SUMMARY

PROPERTY:	84 Centenary Drive Strathfield Formerly, Lot 1 and part Lot 2 in DP 854298 and Lot 1 in DP 130917, now Lots 300 and 301 of DP 1208910 (registered 12.1.2016)
DA NO.:	2015/100
APPLICATION TYPE:	Demolition, tree removal and construction of apartment buildings and townhouses, internal roads and landscaping – staged development
REPORT BY:	Consultant Town Planner
RECOMMENDATION:	DEFERRED COMMENCEMENT
SUBMISSIONS:	Four (4) submissions were received to initial notification, all objecting to the proposal. Three (3) submissions were received to the notification of amended plans, all objecting to the proposal. The final amended plans were not notified.
ZONING:	Part B4 – Mixed Use and part R3 – Medium Density Residential
DATE APPLICATION LODGED:	28 August 2015
APPLICANT:	Alceon Group Pty Ltd – C/- Metro Property Group
OWNER:	Strathfield Golf Club

INTRODUCTION

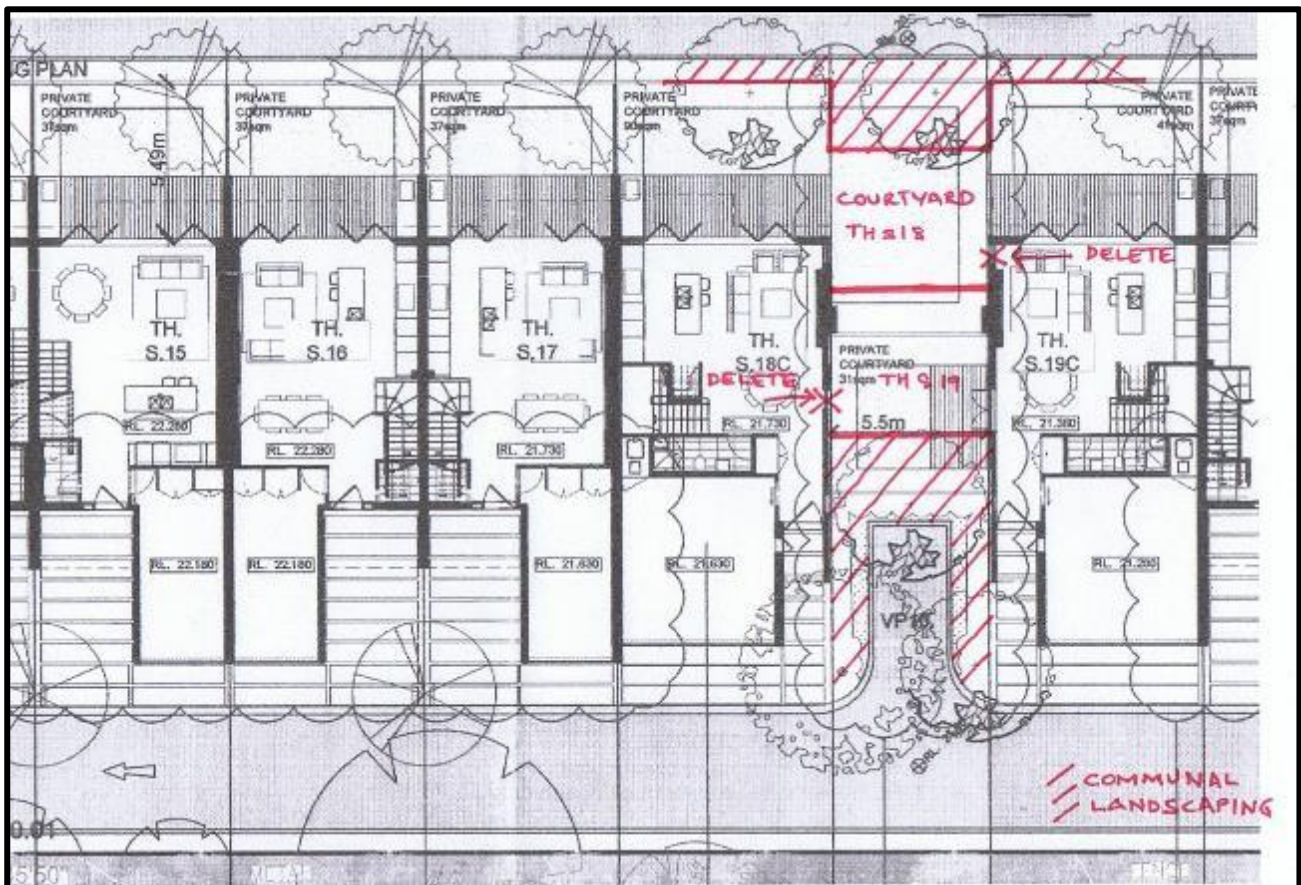
The North-South link roads shall be deleted and the courtyard spaces of the townhouses shall be extended and provided with trees. Additional visitor parking spaces shall be provided where each N-S connecting road has been deleted. Separation between townhouses can be reduced to 5.0m.

The single storey elements shall be deleted in order to break the continuous bulk of the north townhouses and replaced with tree to improve landscape setting. Alternatively, amended landscape plan shall be provided to demonstrate decent landscaping in between townhouses.

The plans have been amended to remove the north/south link roads and courtyard spaces have been provided in this space, along with one (1) visitor parking space. The separation between the townhouses was not reduced and remains at 5.5m. Whilst the amended plans are generally acceptable in this regard, the amended design raises some concerns which are addressed as follows.

The intention of the removal of the north/south link roads was to provide for increased deep soil plantings and to provide a substantial improvement to the landscape setting of the development. The amendments incorporate the vast majority of this space into the private courtyards of the two (2) adjoining townhouses, which as a result has very limited visible improvement to the landscape setting of the townhouses.

These amendments will require changes to the architectural and landscape plans and it is important for Council to ensure the desired landscape setting is achieved. It is therefore recommended that the amended plans be required by way of a deferred commencement condition. The amended landscape plan should incorporate a canopy tree to reach a height of 15m in the 3m landscaped area to either side of the private courtyards. **Condition D2** incorporates these requirements. The following sketch identifies the amendments that are sought by this condition.

In terms of increasing the landscape setting of the northern townhouses, the amended landscape plans show little change. Accordingly, it is recommended that a condition of consent include a requirement to amend the landscape plan to provide for a small tree (5-6m at maturity – can be deciduous) in the courtyard of each northern townhouse. In order to increase the landscaped setting of the area surrounding the single storey components and to allow the bulk to be broken in these locations, the tree to be planted in the courtyards of Townhouses N4, 5, 9, 10, 14, 15, 19 and 20 are to achieve a minimum maturity height of 10m. This requirement is addressed by **Condition D2**.

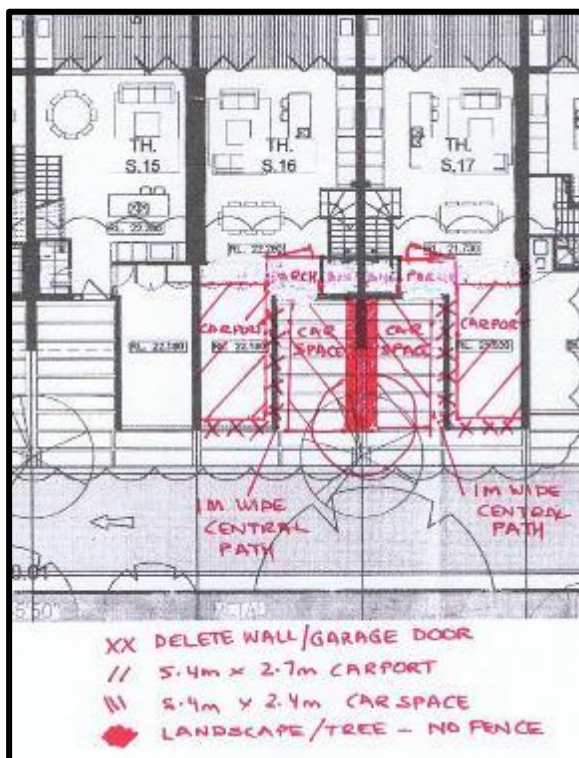
Modifications to provide 2 x B85 parking spaces by reducing the internal layout of the townhouses

Access to front door clear of vehicle (min 950mm)

Access from both sides of car must be provided.

Amended plans have been provided which have increased the width of the open single parking space and increased the depth of that space and the garage to provide for improved manoeuvrability into the spaces along with allowing an access path to the front door clear of the parking space.

The amended plans do not provide sufficient space for appropriate manoeuvring into the space together with suitable access into the dwelling. Further, the modifications made to the plans are at the expense of the landscaped setting at the front of the townhouses. Whilst a tree has been retained forward of the parking spaces, its location inhibits manoeuvrability into the spaces and the spaces are only accessible by way of a three point turn.

The combination of poor accessibility, the proximity that the car would need to be parked to the front door and the loss of landscape setting demonstrate that at 6.8m wide, the townhouses are of insufficient width to provide an appropriate entrance pathway, single garage and open car space.

Accordingly, it is recommended that the plans (both architectural and landscape) be amended to achieve a better outcome for parking, access and the landscaped setting. The following amendments demonstrate an example of one way which this could be achieved:

It is acknowledged that this will reduce the size of the living spaces to these townhouses. Should the above solution not result in an acceptable level of amenity, an alternative would be to delete one (1) townhouse and increase the width of the remaining southern townhouses, although this would have to be achieved within the permitted FSR for the site.

Given the complex nature of the changes required to result in a satisfactory outcome, it is recommended that these matters be included in the Deferred Commencement Conditions. **Condition D2** addresses these modifications.
